Sunnyside Cogeneration Associates

RE: Sunnyside Refuse and Slurry C/007/0035
Request for Phase 1 Bond Release –
Excess Spoil Disposal Area #2 Phase 1 Reclamation

APPLICATION FOR COAL PERMIT PROCESSING

APPLICATION FOR COAL PERMIT PROCESSING
Detailed Schedule Of Changes to the Mining And Reclamation Plan

SHEET 5-2

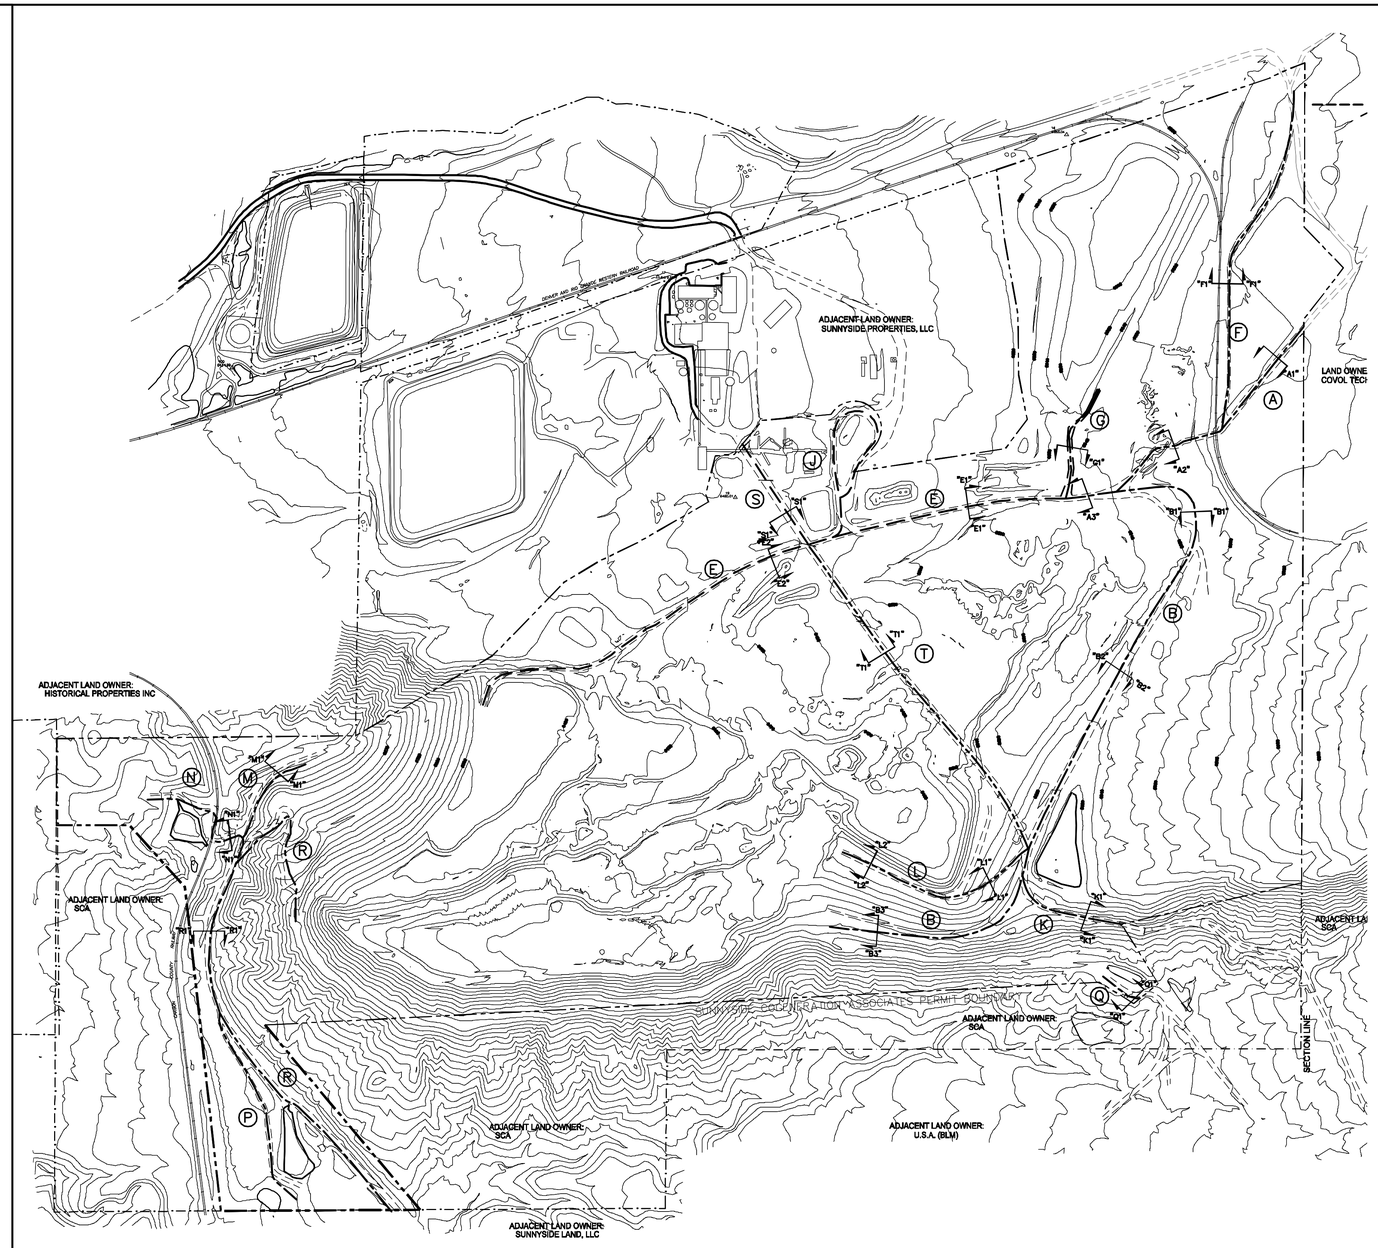
REV	DATE	DESCRIPTION	BY	APP'D
10	1/16	ROAD RECLAMATION UPDATES	AH	
9	7/15	WEST PASTURE AND REFUSE PILE ACCESS ROADS	AH	
8	11/10	BOUNDARY AND TOPO UPDATE	AH	
7	2/07	CHANGE IN ROAD H	AH	
6	9/02	2002 PERMIT RENEWAL	PAM	
5	9/94	CHANGE IN ROAD B AND R	AJZ

SHEET 5–2D

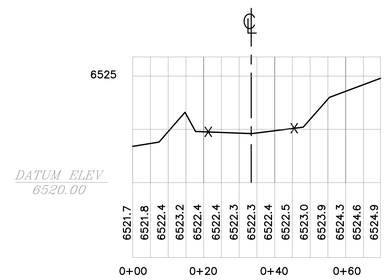
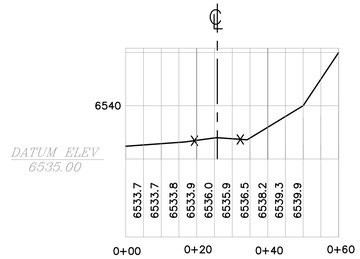
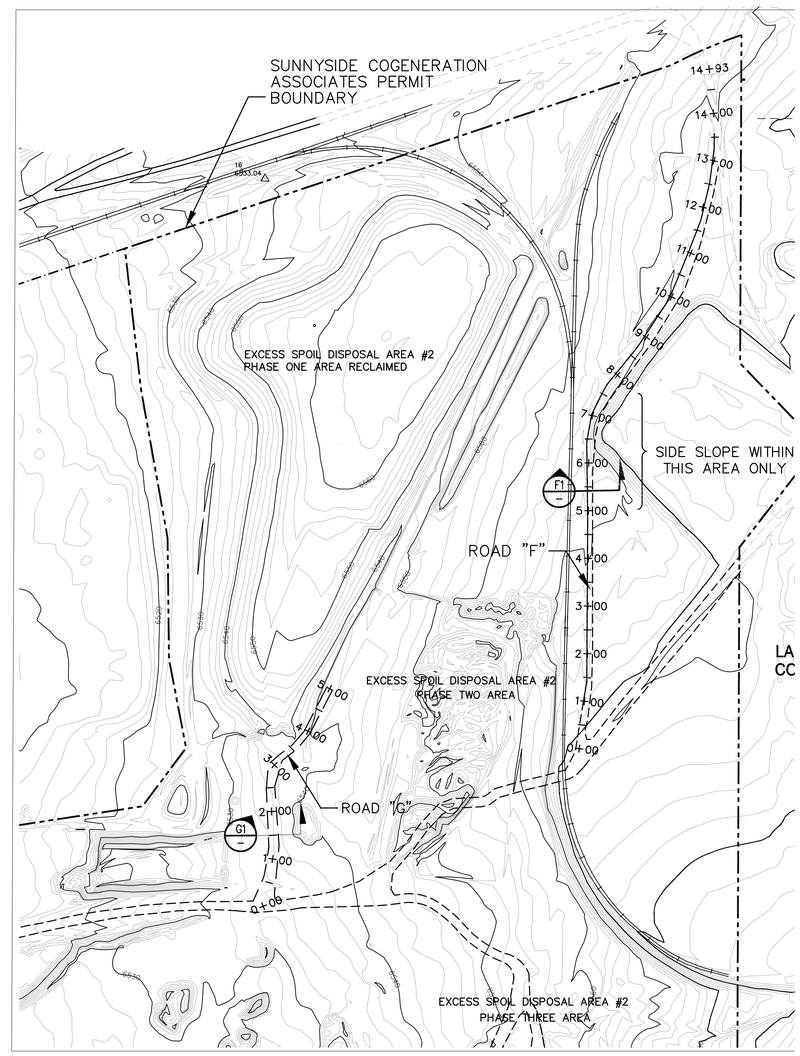
REV	DATE	DESCRIPTION	BY	APP'D
5				
5	1/16	ROAD RECLAMATION UPDATES	AH	
4	11/10	BOUNDARY AND TOPO UPDATES	AH	
3	9/02	2002 PERMIT RENEWAL	PAM	
2	9/97	PERMIT RENEWAL– UPDATE	CAC	
1	2/94	REVISED SECTIONS	AH

7-1

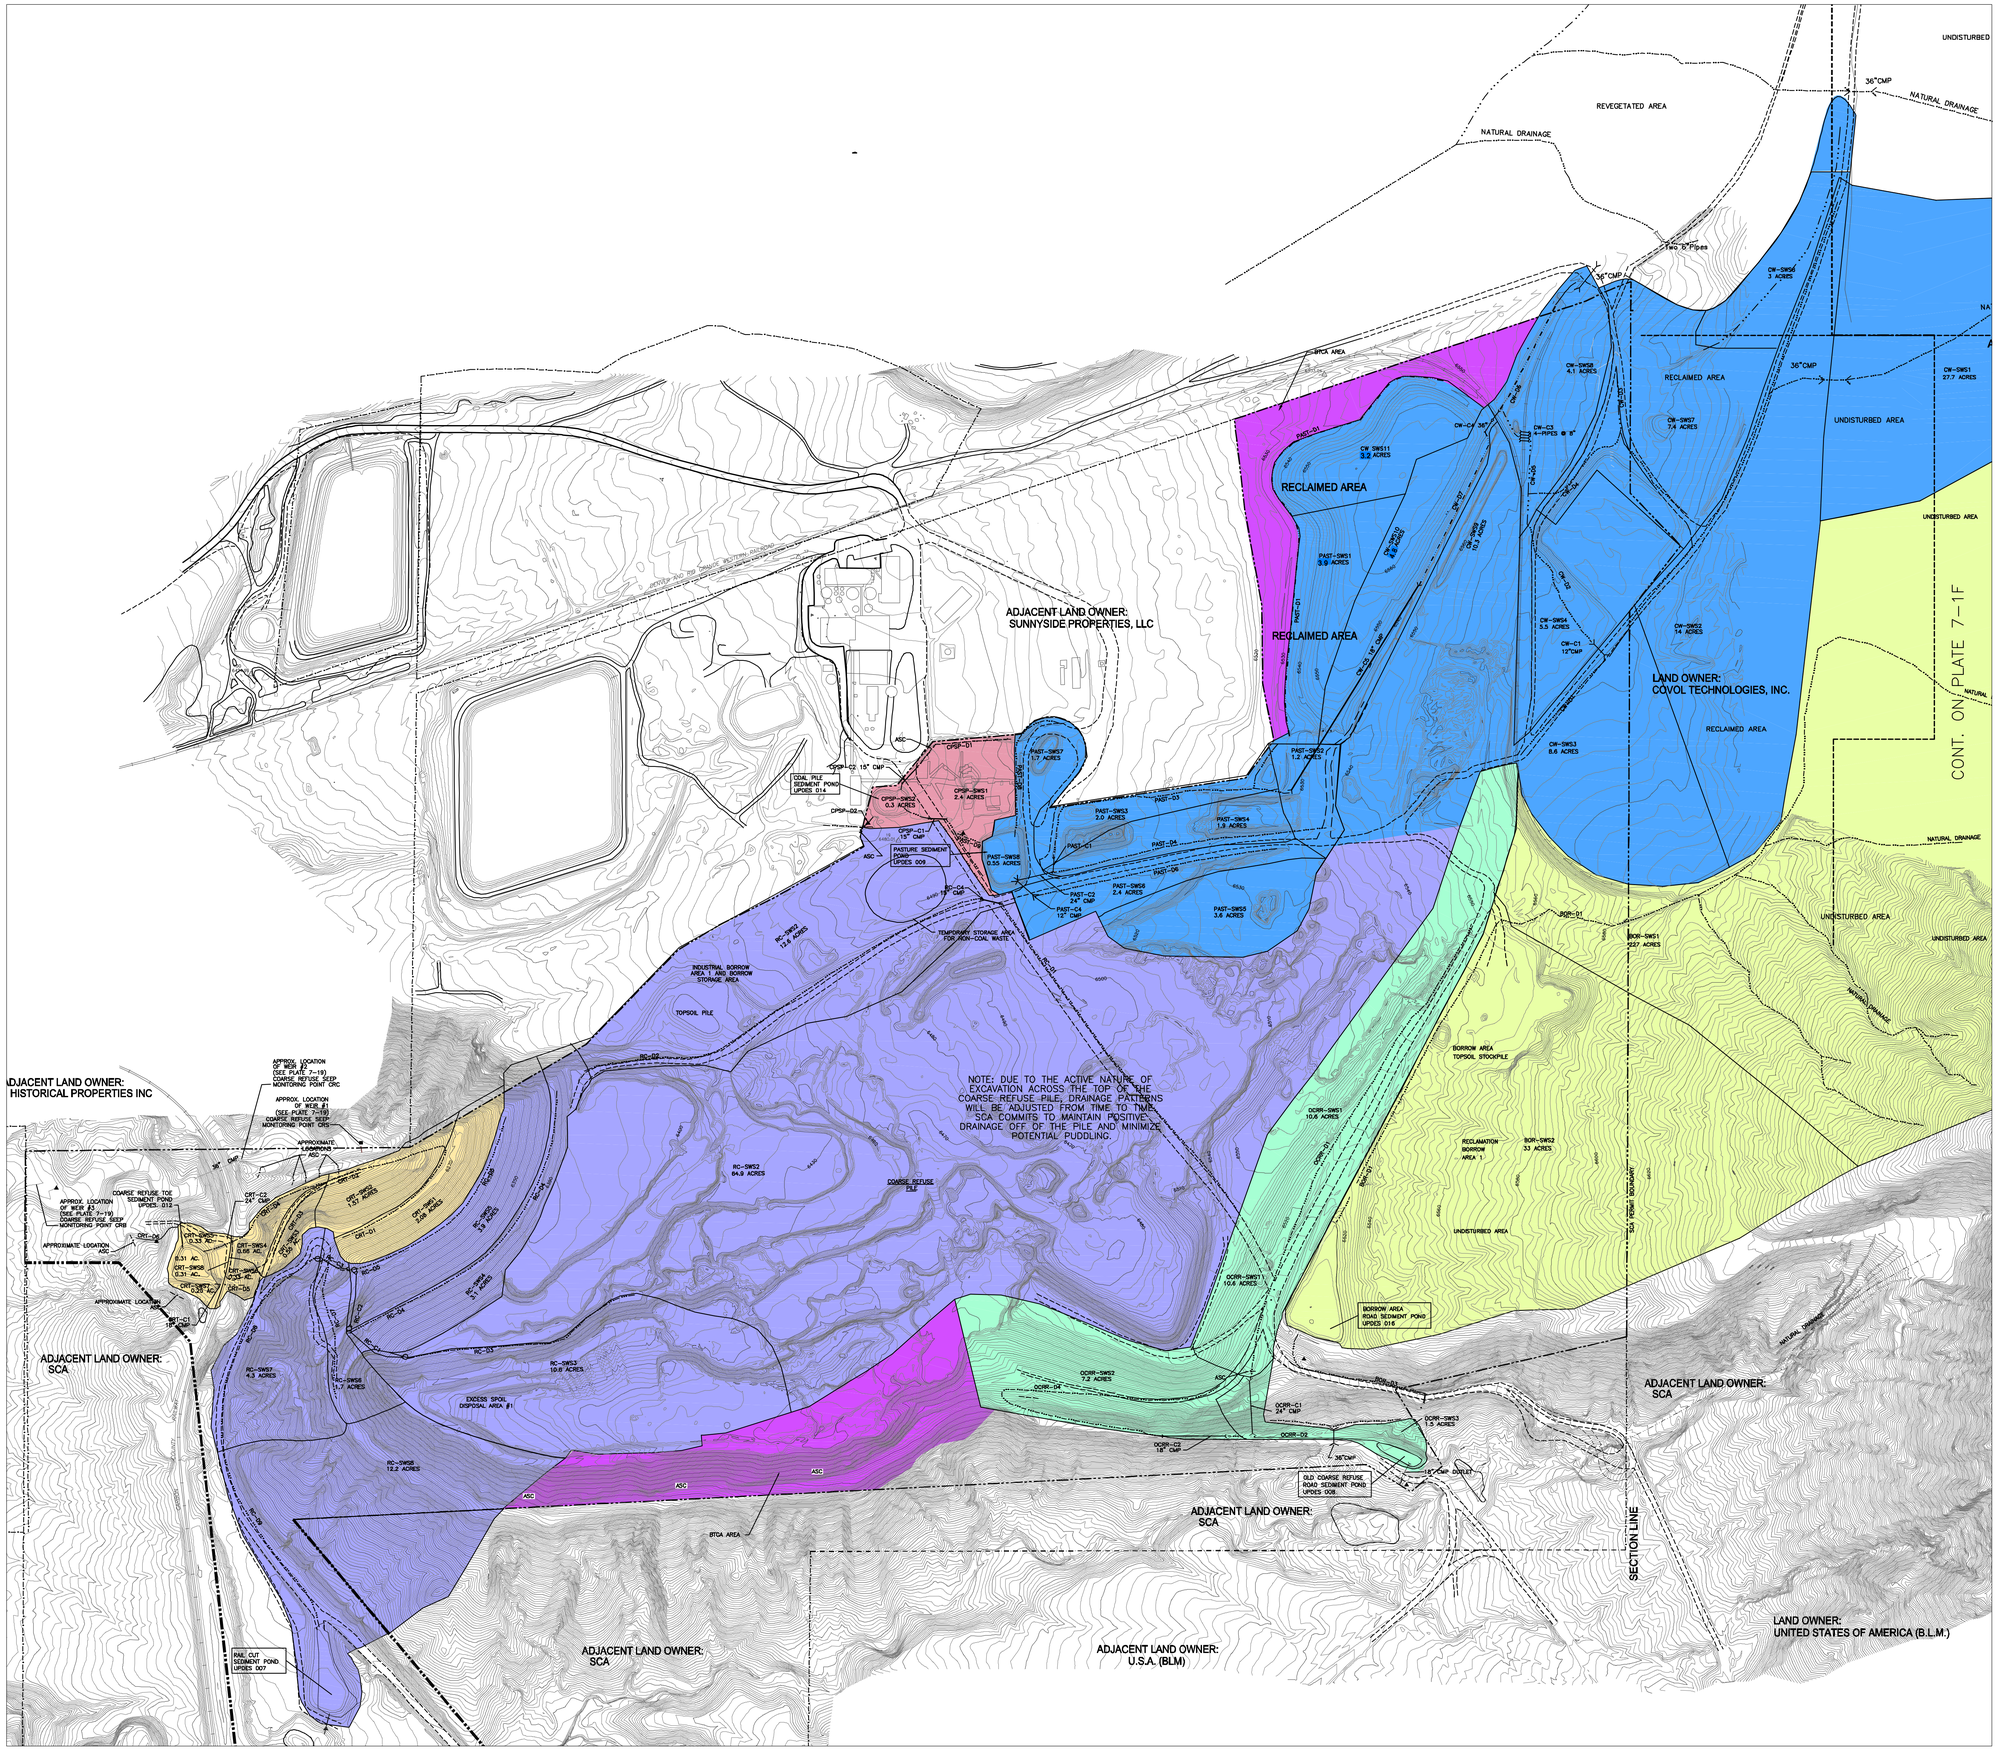
REV	DATE	DESCRIPTION	BY	APP'D
17	1/16	EXCESS SPOIL DISPOSAL AREA RECLAMATION UPDATE	AH	
16	7/15	REMOVE CULVERTS IN PASTURE POND DRAINAGE AREA	AH	
15		ADD DITCHES AND CULVERTS IN RAIL CUT DRAINAGE	AH	
14	11/10	BOUNDARY UPDATE	AH	
13	8/10	UPDATE SITE AND TOPO	AH	
12	5/08	MOVE PASTURE POND CULVERT-C1	SSC	
11	5/07	UPDATE PASTURE POND	AH	
10	3/06	UPDATE DRAINAGE AREAS	AH

8–1

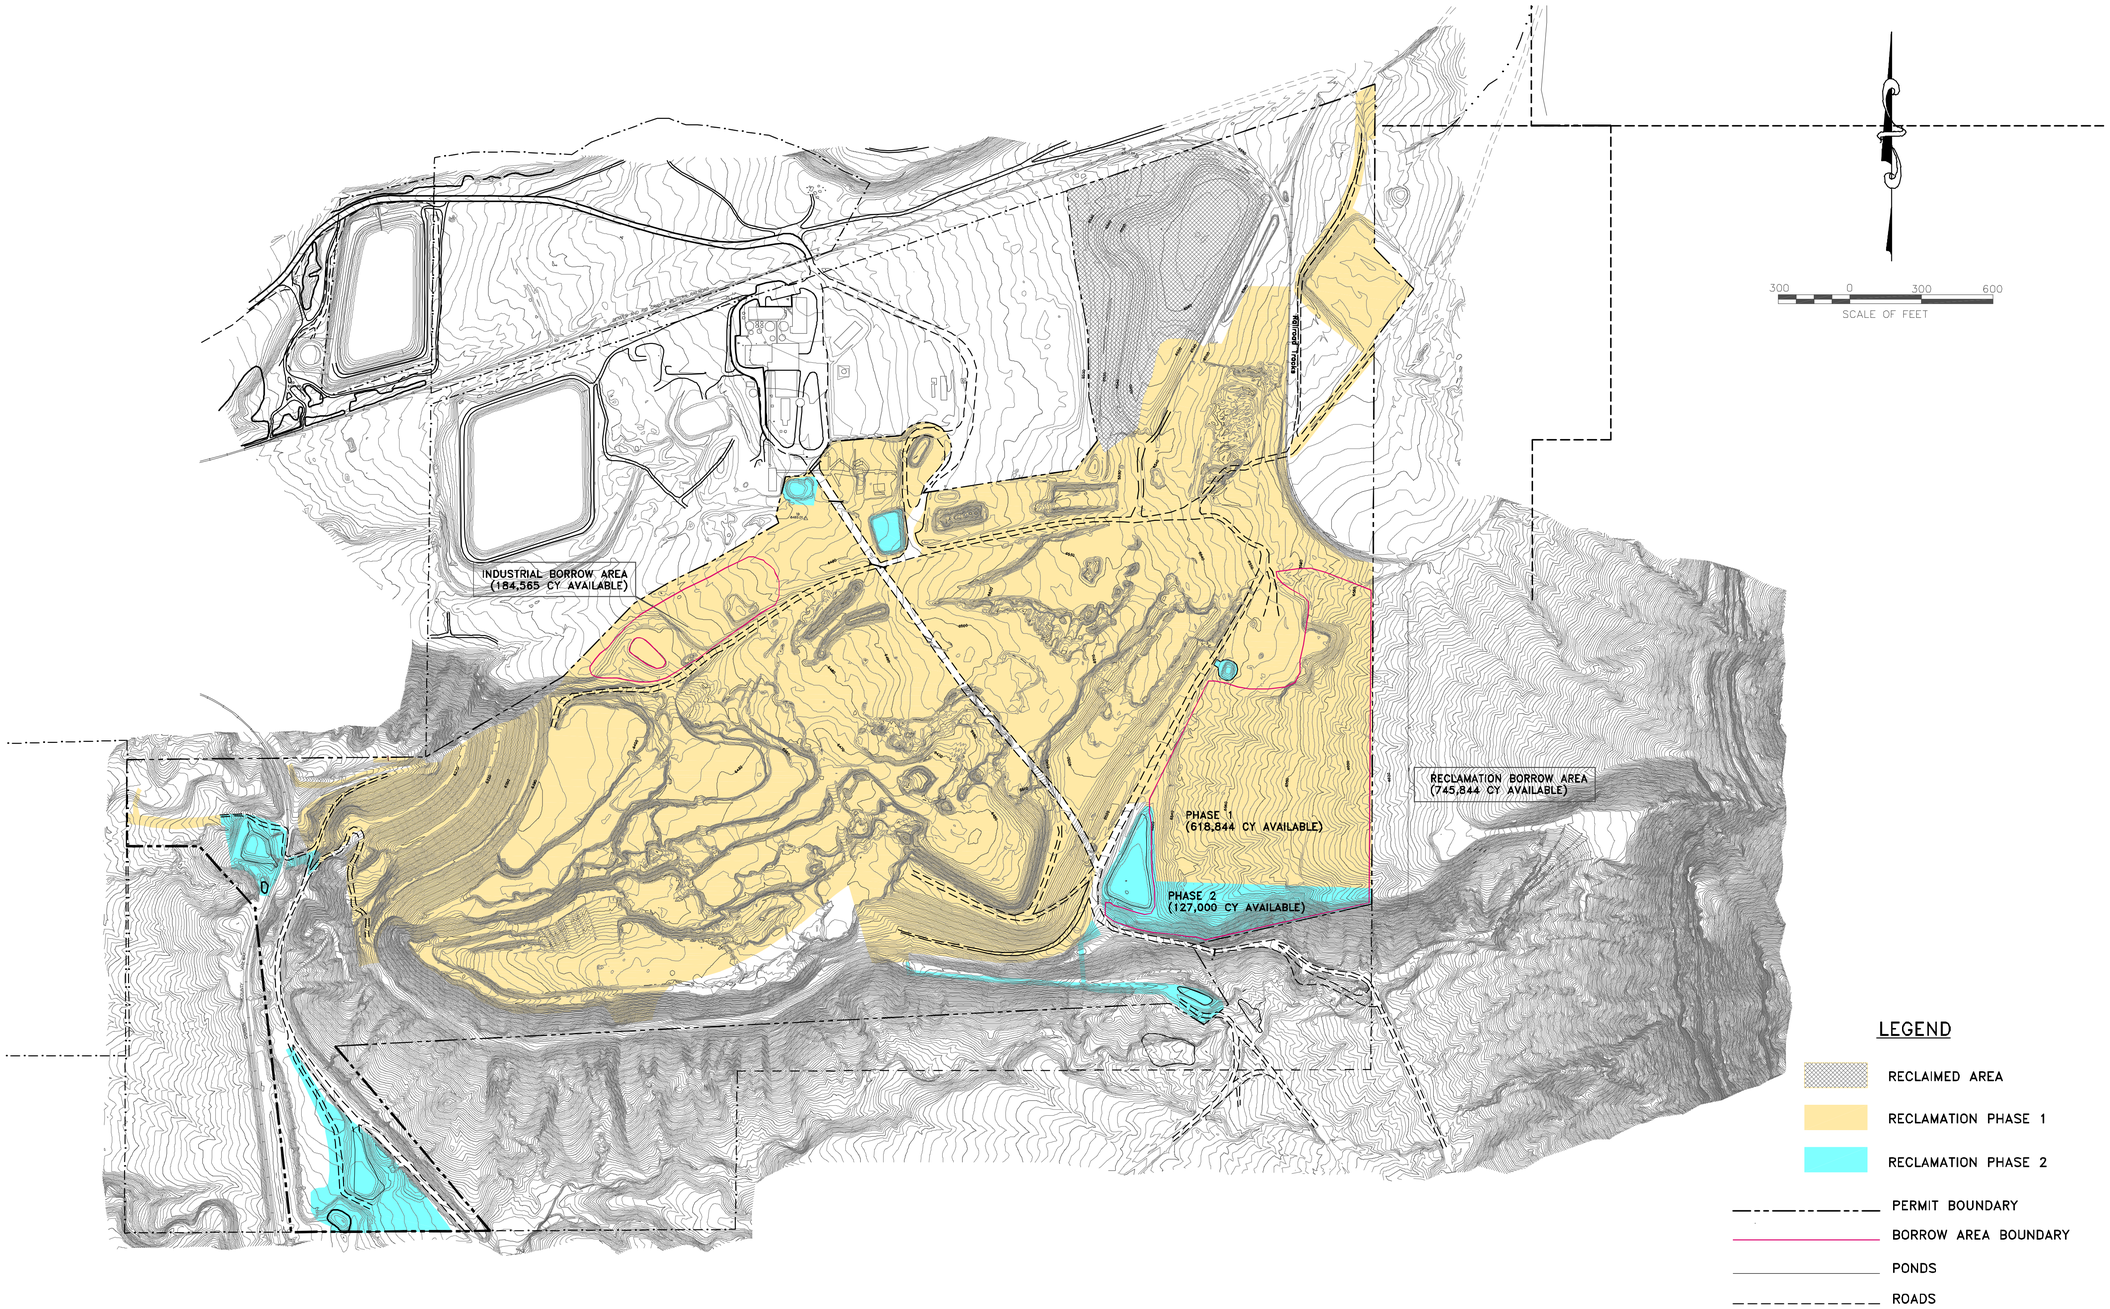
REV	DATE	DESCRIPTION	BY	APP'D
5	1/16	EXCESS SPOIL DISPOSAL AREA 2 PH 1 RECLAMATION UPDATES	AH	
4	6/11	EXCESS SPOIL DISPOSAL AREA 2 CHANGES	AH	
3	11/10	BOUNDARY AND TOPO UPDATES	AH	
2	9/02	2002 PERMIT RENEWAL	AH	
1	9/97	PERMIT RENEWAL– UPDATES	AH
